**Cavern Integrity Report
H. C. Clark, Ph.D.**

Cavern Integrity Analysis
Finger Lakes LPG Storage, LLC

January 15, 2015

Figure 5: Wells 27, 28, 30, and 31
Source: Jacoby 1969

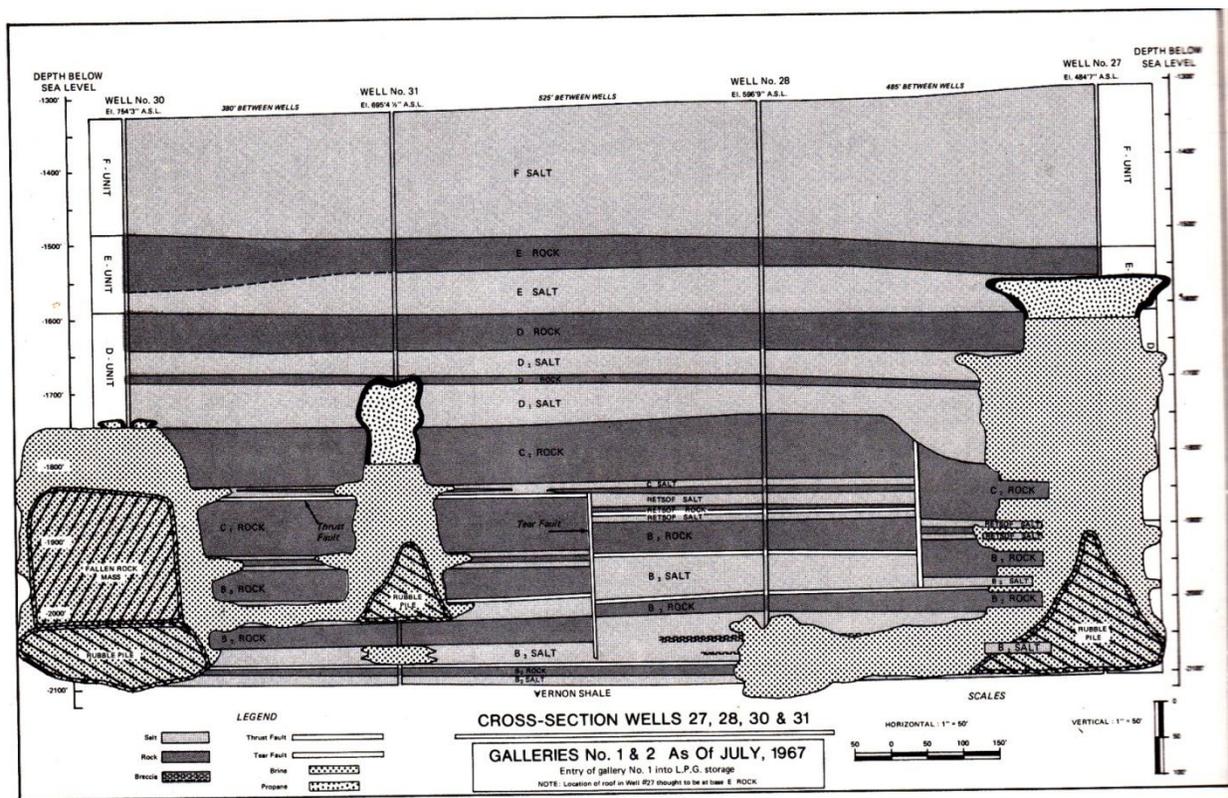
Figure 5, below, was developed after their initial hydraulic fracture connection. It provides a clearer picture of the actual situation here, in contrast with the current open space measured by recent sonars above beds depicted as continuous on FLLPG cross-section AA'. The information on this Jacoby cross-section should be disclosed on cross-section AA', but it is not.

Figure 5 shows the outlines of the caverns, the hydraulic fracturing connections between caverns, thrust faulting and tear faulting, in addition to the more detailed stratigraphy here that Jacoby developed from core samples and geophysical logs. The notation in the middle of the rectangular shape at the base of Cavern 30, "Fallen Rock Mass," describes a 400,000-ton block that fell from the roof (outlined by sonar). I have sketched the cavern outlines developed from the 1967 sonars on cross-section AA' and have attached the marked cross-section as Exhibit B to this report, to allow comparison.

Figure 7: Clark Mark-Up of Cavern 58 Cross-Section
Source of Cross-Section: FLLPG (filed Oct. 23, 2014)

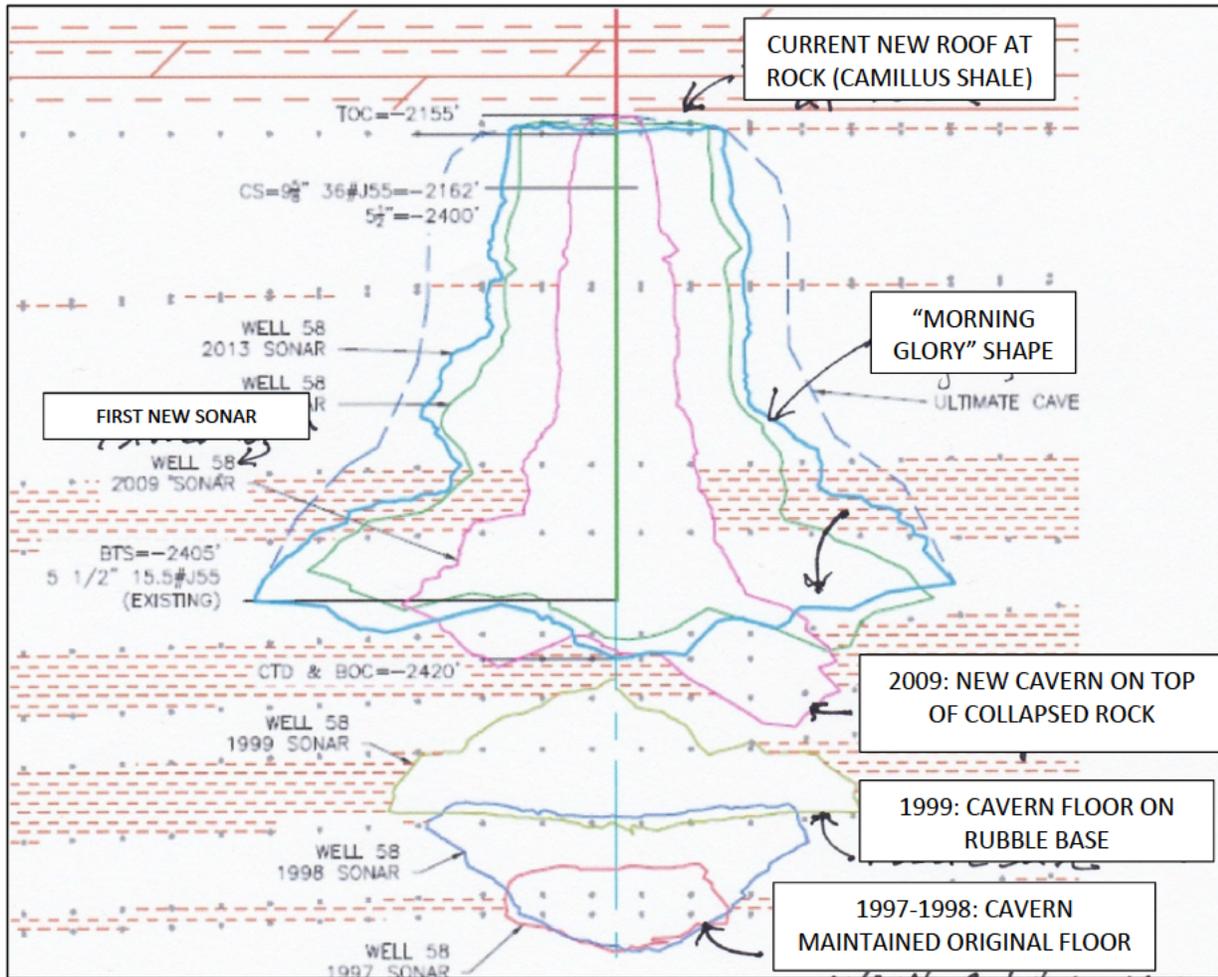
Figure 7 below is my mark-up of the portion of cross-section AA’ depicting Cavern 58, which is FLLPG Gallery 2. This cavern has been a focus of concern for a long time. It could be described as the combination of two caverns: (1) the new one with its roof at the Camillus shale, the upper bound of the interbedded salt and rock layers, and with its base outlined by the 2009 sonar, with a “morning glory” shape, and (2) the original attempt at cavern development, below the new one, as outlined by the 1997–1999 sonars, which now is filled with rubble, the result of a roof collapse and consequent abandonment. FLLPG shows them as isolated on cross-section AA’, but in fact they are connected, as I show on Exhibit B.

Moreover, there is evidence not only of past cavern failure but also of current roof instability. The sonars in cross-section AA' show that the roof in 2009 is higher than in 2011 and that, by 2013, the roof is visibly sagging. [REDACTED]

The sagging occurs even as the extent of the roof grows, adding to the risk of collapse. Finally, Cavern 58 extends to the Camillus shale; there is no salt layer to provide support for the roof.

Marked Cross-Section AA'

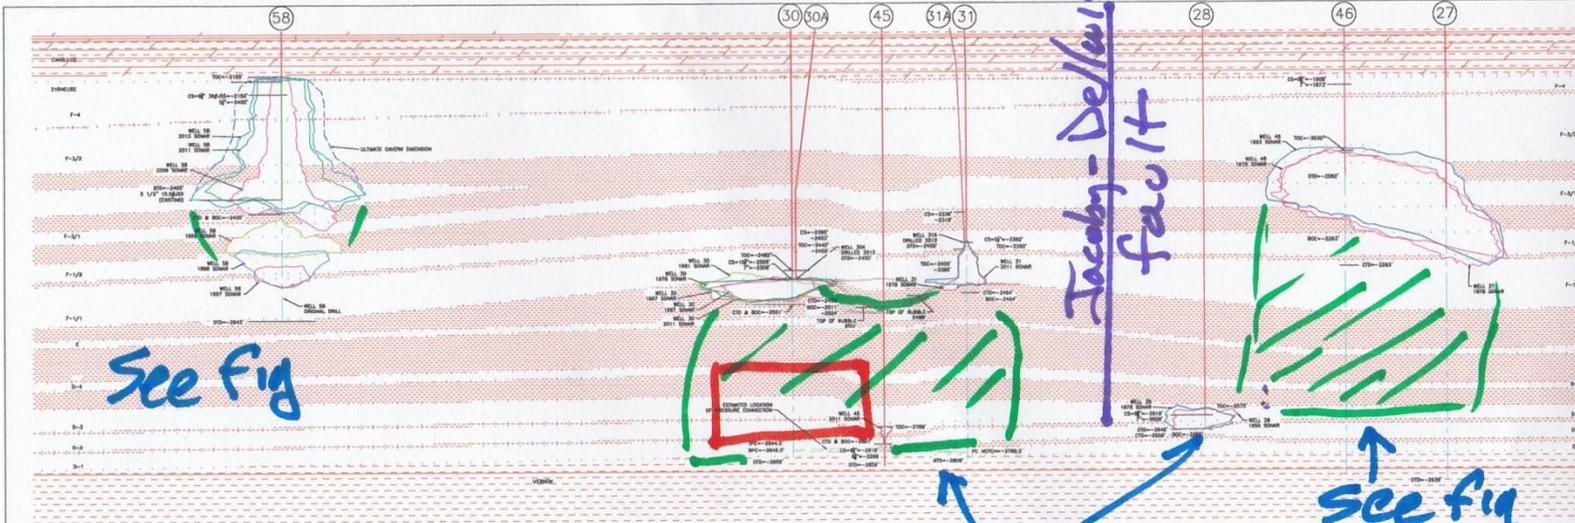
Cavern 58 will be discussed in more detail later, but some basic information requires immediate correction. Two rock layers are depicted abutting Cavern 58 in unlikely locations. One layer is shown a third of the way up in the new cavern being solutioned above the collapsed original and passing through the 2011 and 2013 sonar outlines (likely a drafting error). The other rock layer, shown beneath and apparently supporting the new Cavern 58, conflicts with the underlying information in the application. The implied structural support beneath the new Cavern 58 raises an important question: Is the layer real, making its future over the previous Cavern 58 rubble pile somewhat precarious? Or, is the new Cavern 58 floored on the rubble of the lower Cavern 58 roof collapse, and the continuous bed pictured an error? According to the well status report in the Reservoir Suitability Report, the base of the new Cavern 58 is “top of rubble,”⁸ making the depiction as solid rock an error. The phrase “top of rubble” here and at several places on the cross-section indicates that there is rubble between the old and new cavern floors and that, as Cavern 58 has been solutioned, the relatively insoluble interbedded rock has fallen and filled the base of the cavern. A complete cross-section should show the volumes now filled by this rock. The rubble-filled historic cavern outline for Cavern 58 is shown on Exhibit B.

My mark-up of cross-section AA' in Exhibit B shows cavern outlines and the Jacoby-Dellwig Tear Fault, shown in Figure 3 above between Caverns 31 and 28 and in Figure 4 parallel to the shore of Seneca Lake. Thrust faulting shown on the Jacoby cross-section and discussed in his 1973 article with respect to the thickened salt in Well 27 also should be added to cross-section AA'. The locations of the thrust faults were developed from the repeated signatures shown on gamma logs from Wells 27, 28, 30, and 31 and discussed in several Jacoby papers. Jacoby discussed subsidiary faulting related to both of the major faults shown on his cross-section, and that faulting should be recognized and plotted on cross-section AA'. The original sonar information and the geophysical logs that were the basis for Jacoby's cross-sections and

Summarizing the review of FLLPG cross-section AA': the depiction of rock and salt layers beneath sonar outlines of Caverns 58, 30 and 31, and 28 and 27 as continuous is incorrect and misleading; there are rubble-filled caverns here that have been solutioned upward through time, and this area should be shown not as a continuous red pattern and white area meant to characterize intact rock layers, but rather with a rubble symbol, [REDACTED]

interpretations—and that are necessary to provide a complete account of the geology in the area covered by cross-section AA—are likely in salt company files available to FLLPG. Once completed, the revised cross-section AA’ should show the thrust faults and tear faults that explain the variations in salt and rock layers shown on the 8/28/14 cross-section AA’ now in the application.
